**Town of Rotterdam
Planning Commission
June 18, 2024**

Agenda (V. Dalton Bambury Hearing Room 2nd Floor) – 7:30pm

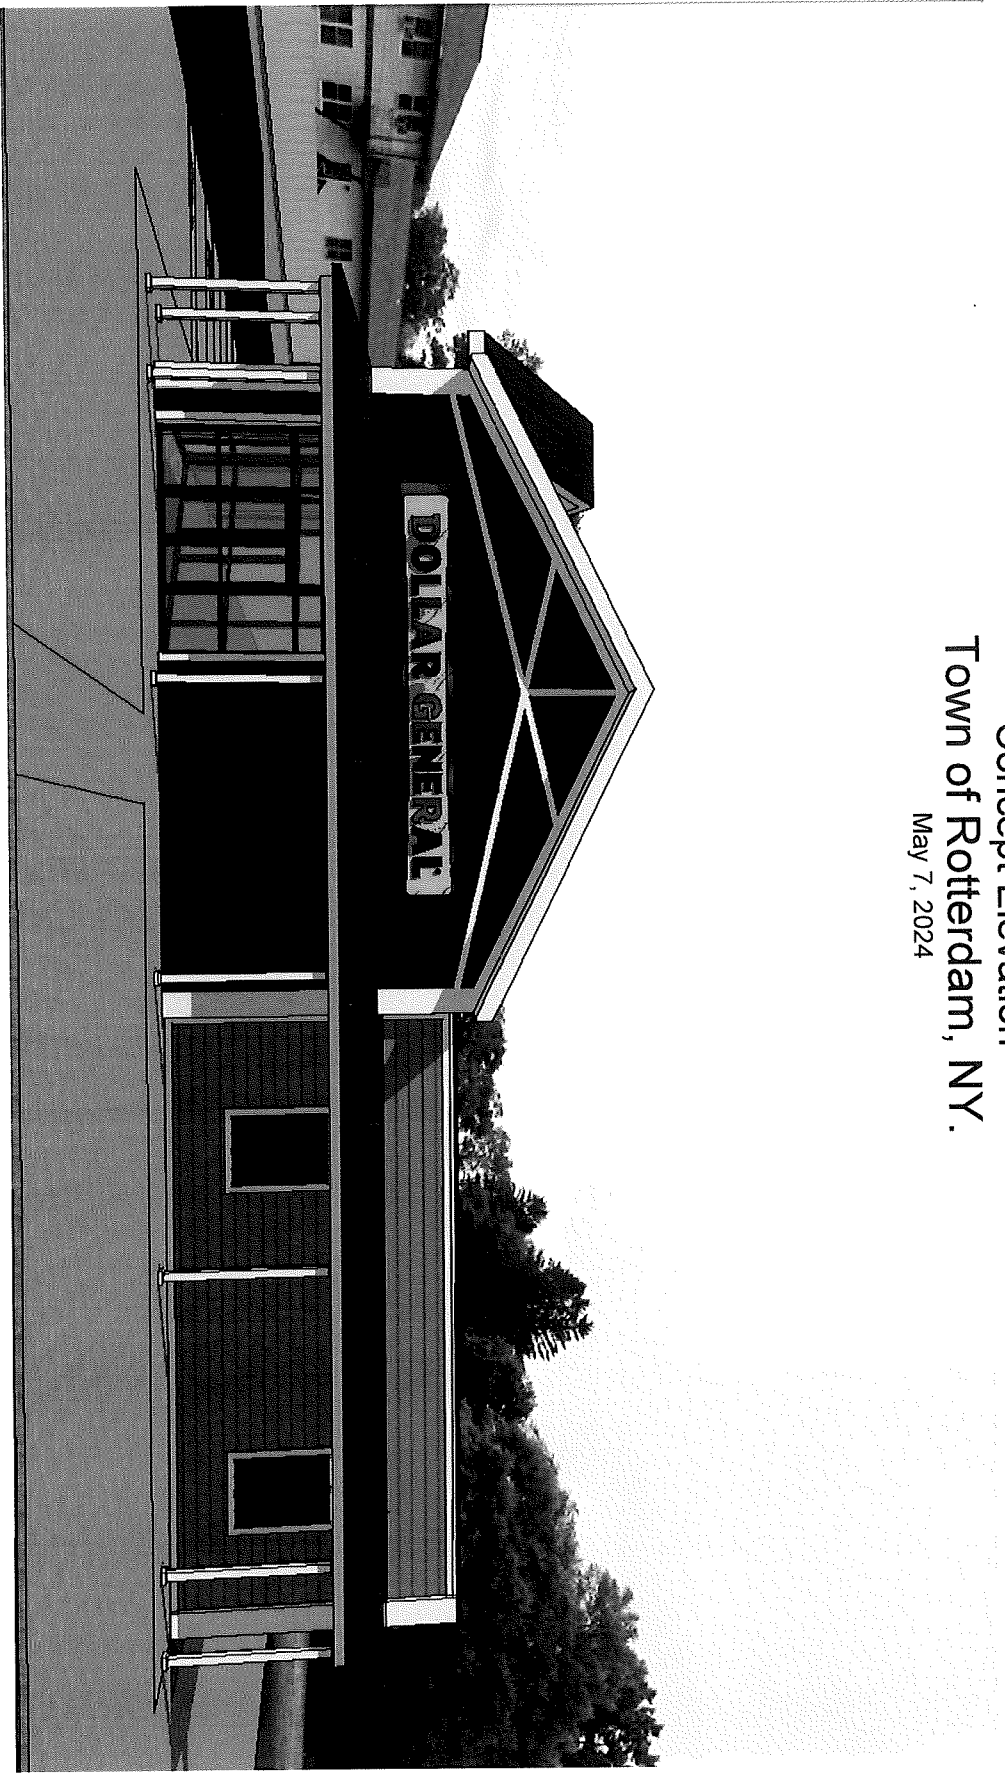
3. Bollards should be installed (add to detail sheet) in parking areas abutting the building as well as added near the electrical box on the exterior of the building.

4. Detail lighting fixtures and poles. Pole lighting height should be reduced and may need additional poles and shielding for adjoining residential apartments to the north. LED lighting should have a lower kelvin rating in the 3000 to 4000 range.

7. Detail dumpster enclosure. A similar enclosure that was utilized for the Rotterdam Junction Dollar General should be considered.
8. Label ground cover in all locations. Planning Commission prefers grass.

9. Applicant should consider eliminating shrub planting areas along Hamburg Street and replace with additional flowering trees such as dogwood. Planting beds are more difficult to maintain.
10. Applicant should consider eliminating split rail fencing around stormwater basin. Based upon percolation rates it is highly unlikely that these basins will retain water for any length of time.
11. Applicant should consider installing decorative fencing and brick pilasters every 8-10 feet along Hamburg Street.
12. Proposed 6' stockade fence along northern property line should be replaced with either white or gray vinyl.
13. Cover Sheet index should be amended (C-803 should be labeled C-802).

The Site Plan has been revised to show bollards in front of parking spaces adjacent to the electrical box, as well as parking spaces where there is no full 6" curbing. A bollard detail is shown on Sheet C-901.

A bollard detail is shown on sheet C-901.

Front Left
Elevation

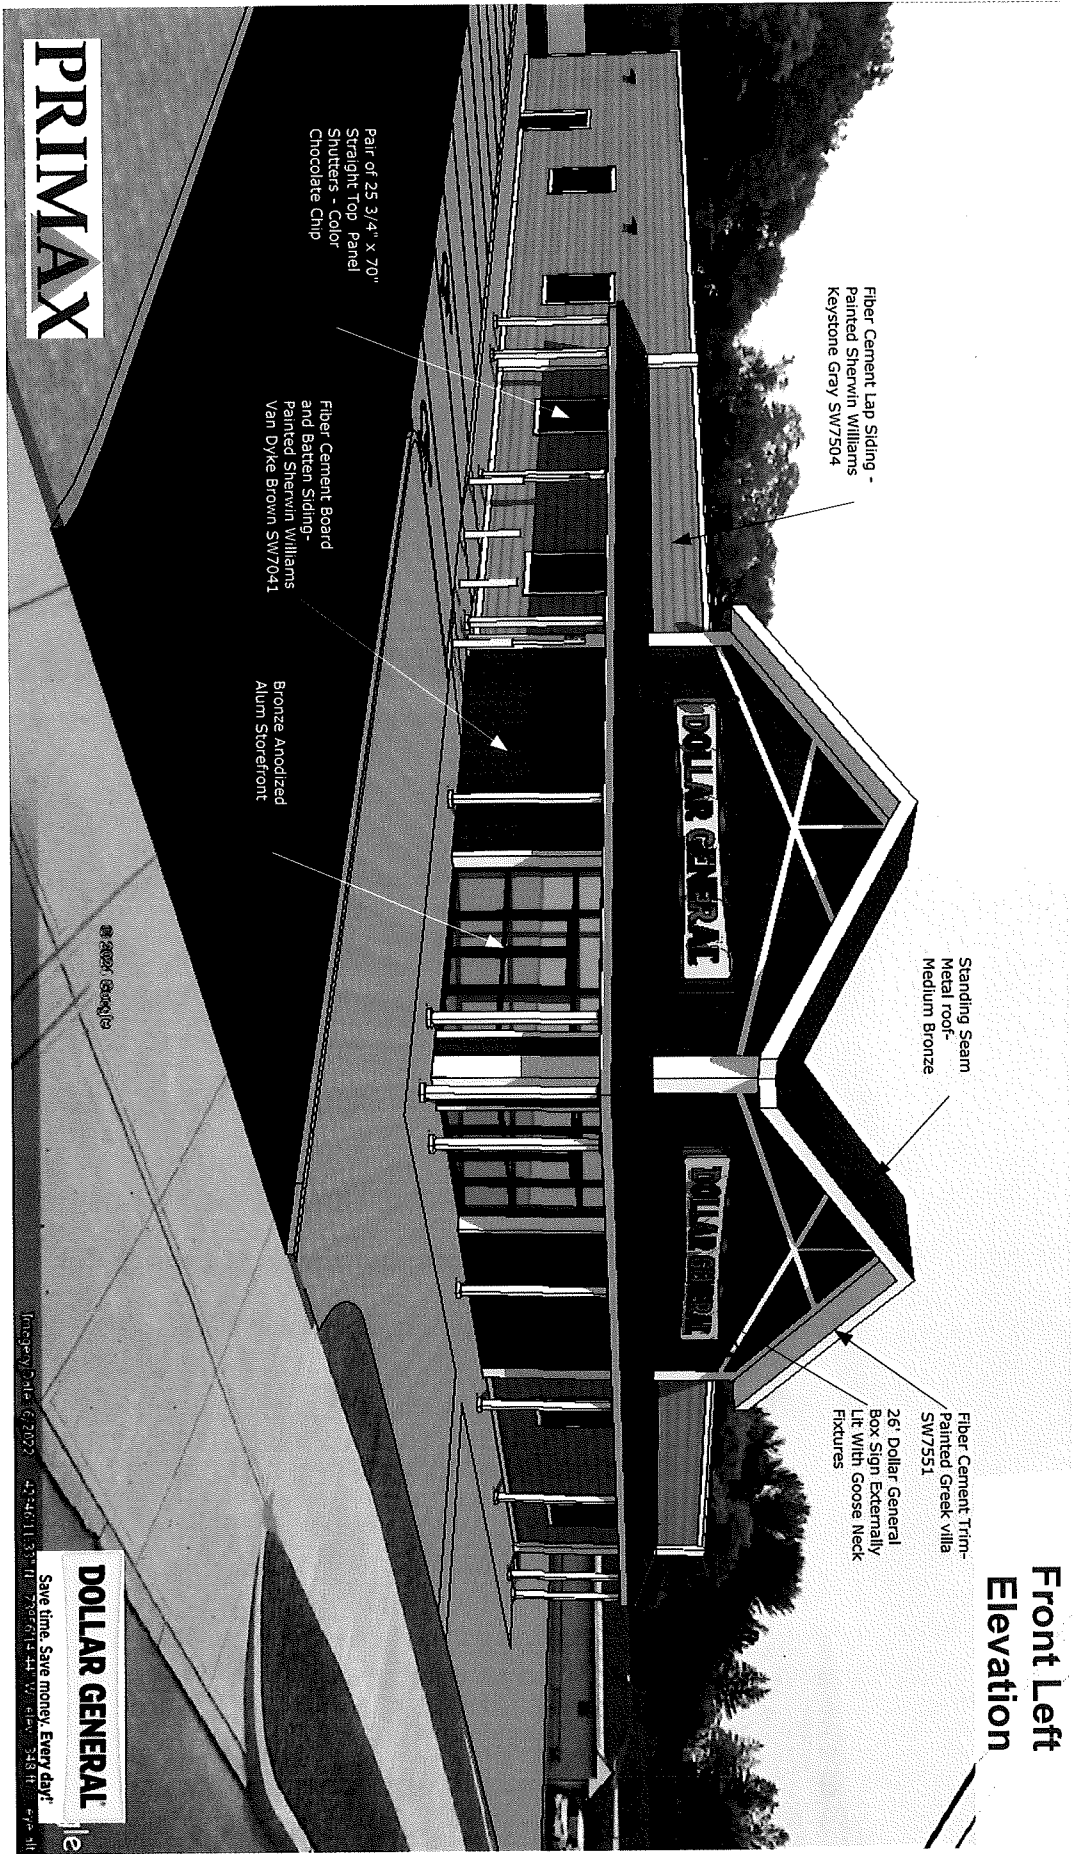
1. See response letter from Bohler Engineering dated April 24, 2024 in reply to DPW and TDE comments.
2. Building elevation and color scheme is much improved and blends in with the surrounding area.

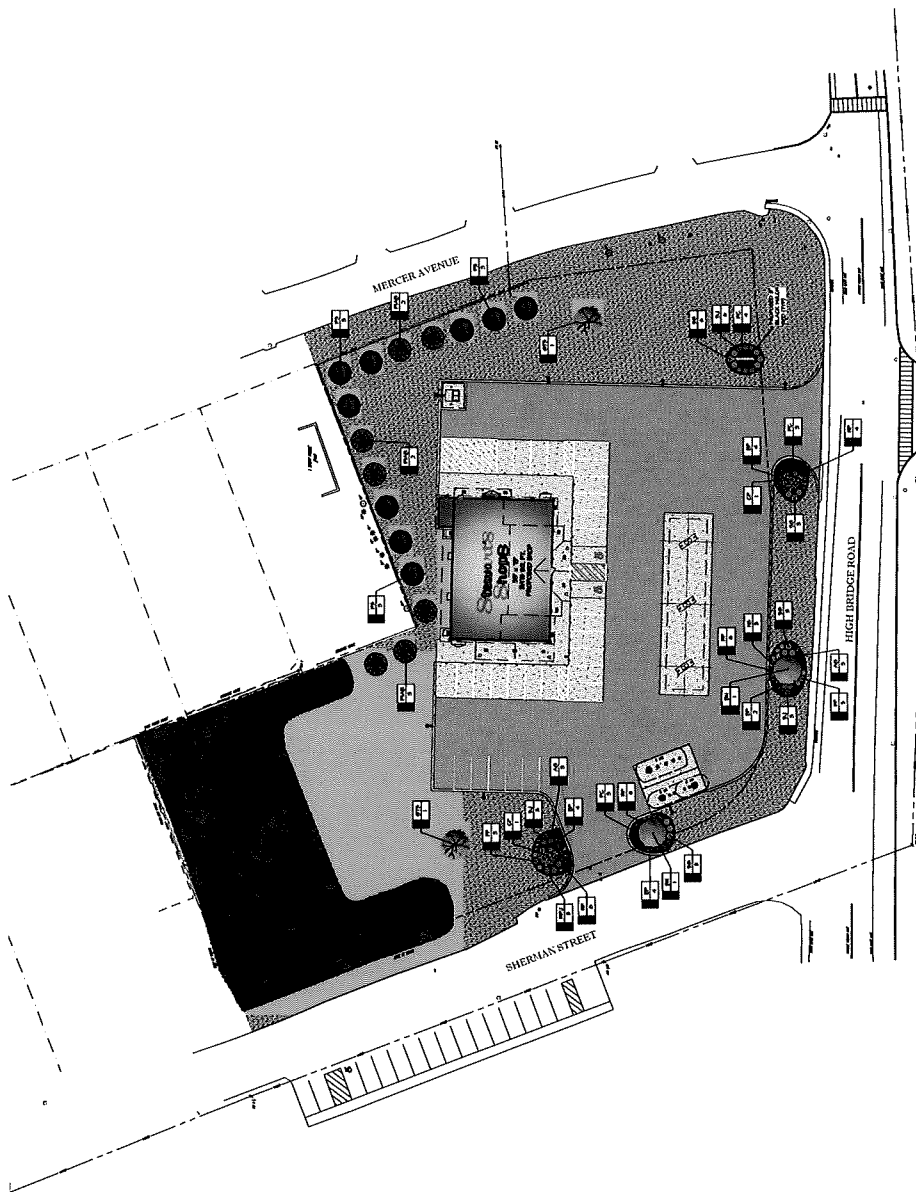
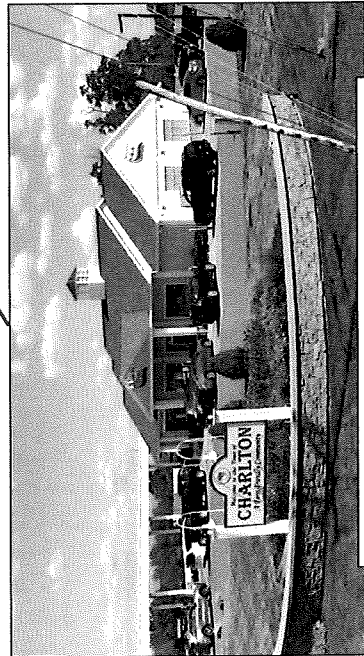
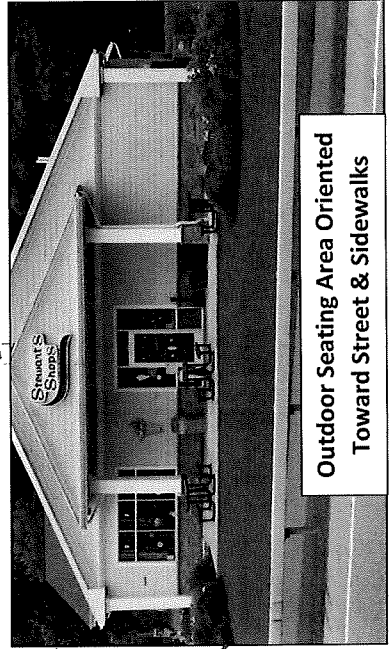
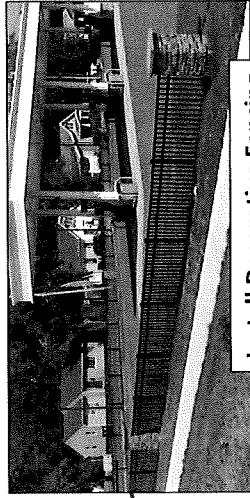
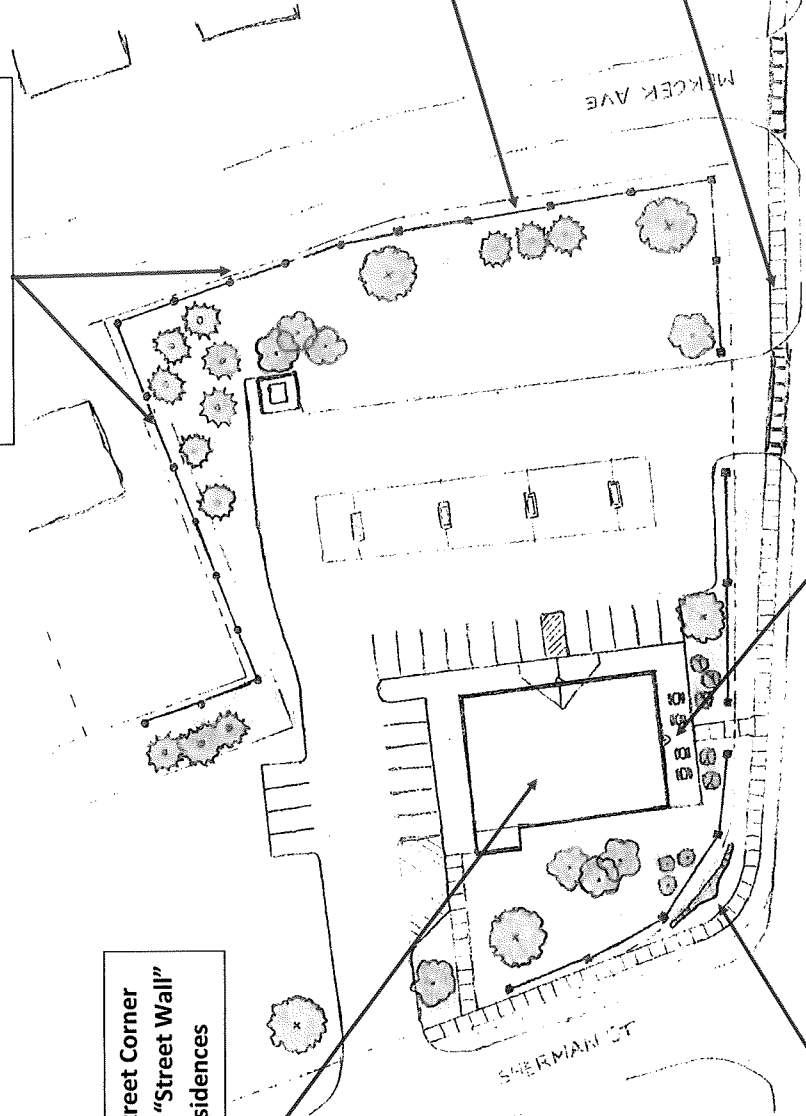
Provide Vinyl Privacy Fencing

Reorient Building to the Street Corner
Maintain Existing Building "Street Wall"
Increase Distance from Residences

Install Decorative Fencing
